## PROPOSED MIXED-USE DEVELOPMENT 42 UNLEY ROAD, UNLEY MINOR PARKING ALTERATIONS

I refer to the proposed mixed-use development at 42 Unley Road, Unley, and specifically, the minor changes to the rear (unsecured) parking area adjacent Irwin Lane. The changes are illustrated on plans prepared by Enzo Caroscio Architecture (project no. 220006, drawing no. A2.00, revision A6, dated 04 April 2025), attached to this letter.

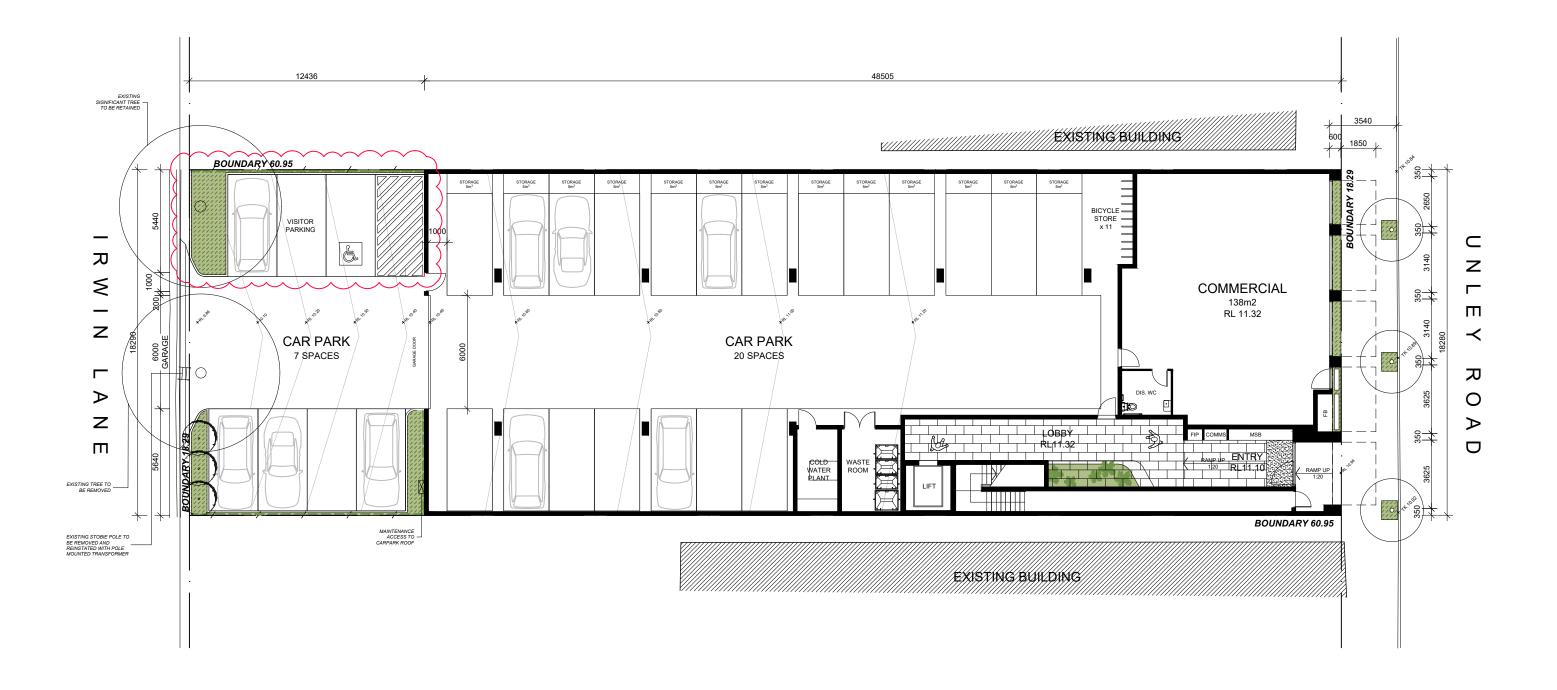
Of relevance to this letter, the parking space reserved exclusively for people with disabilities has shifted from the western end of the northern row to the eastern end of the northern row. The shared parking area is now located directly adjacent the wall of the secure parking area, with the disabled parking space located adjacent.

All external parking spaces measure at 2.6 m wide and 5.4 m deep, thereby exceeding the minimum width dimensions of the Australian/New Zealand Standards for "Parking Facilities – Part 1: Off-street car parking" (AS/NZS 2890.1:2004) and "Parking Facilities – Part 6: Off-street parking for people with disabilities" (AS/NZS 2890.6:2022). No changes to the adjacent aisle width are proposed.

I therefore confirm that the changes to the parking area shown on the attached plan are compliant with AS/NZS 2890.1:2004 and AS/NZS 2890.6:2022. Please feel free to contact me on (08) 7078 1801 should you require any additional information.
